ATTACHMENT 1  
PROPOSED TECHNICAL SPECIFICATION AMENDMENTS

CATAMBA - UNITS 1 & 2

ATTACHMENT II  
DISCUSSION AND NO SIGNIFICANT HAZARDS CONSIDERATION ANALYSIS

CONTAINMENT PRESSURE CONTROL SYSTEM LOGIC

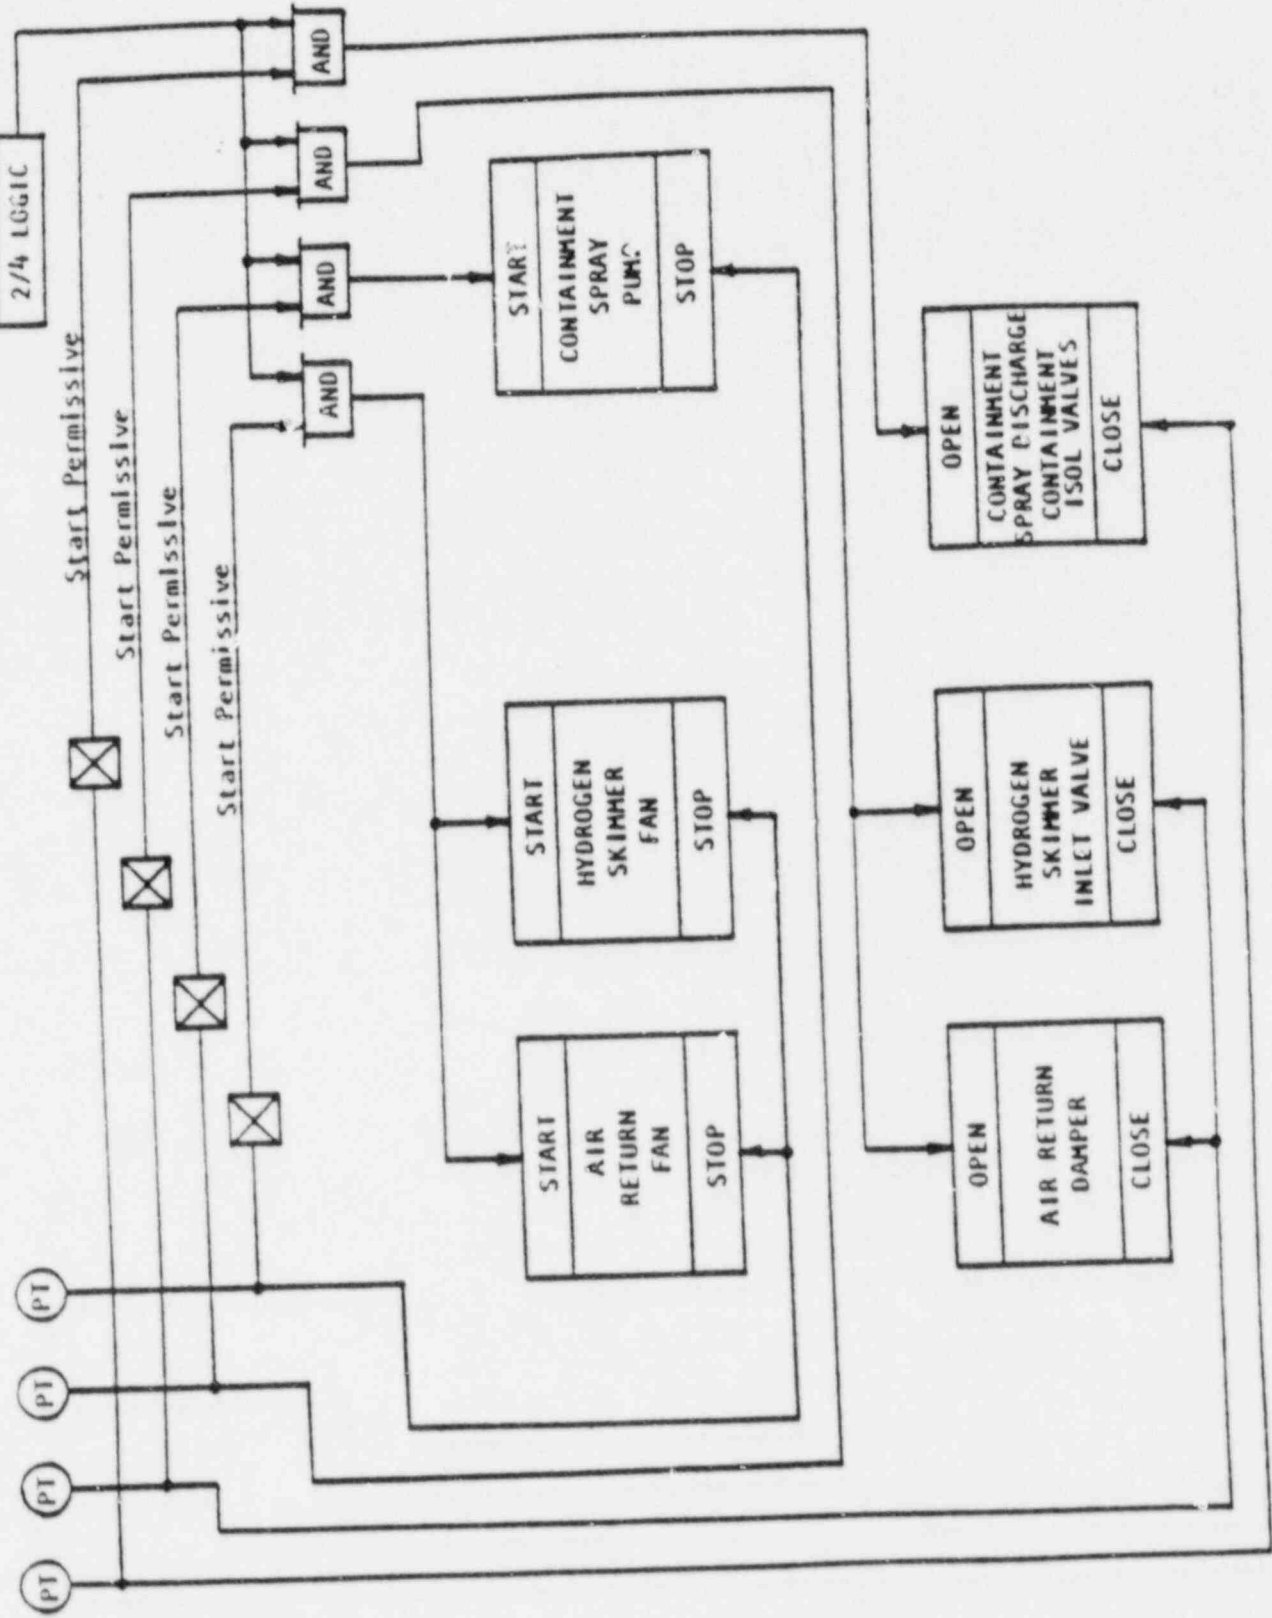
The start permissive and termination features of the redundant trains of the Containment Pressure Control System are provided by eight independent pressure sensors (four per train). These pressure sensors interlock the controls of the NS System and the VX Fans and Hydrogen Skimmer System to prevent their operation when containment pressure is below approximately 0.25 psig. The CPCS control logic is presented in the attached Figure.

The proposed Technical Specification changes are intended to clarify and provide further detail of the functions of the CPCS. The changes would also add a CPCS specific ACTION statement which would direct plant personnel to place any inoperable CPCS channels in the safe (start permissive) mode and either place the unit in a shutdown condition or apply the applicable VX or NS ACTION statement depending on the number of inoperable channels. This is more conservative than the current ACTION statement since the proposed ACTION statement and the VX and NS specifications contain shutdown requirements whereas the current CPCS ACTION statement would allow continued operation. Please note that the proposed ACTION Statement is ACTION 29. A new ACTION 28 was proposed in my letter dated March 11, 1988 concerning item 8.f.
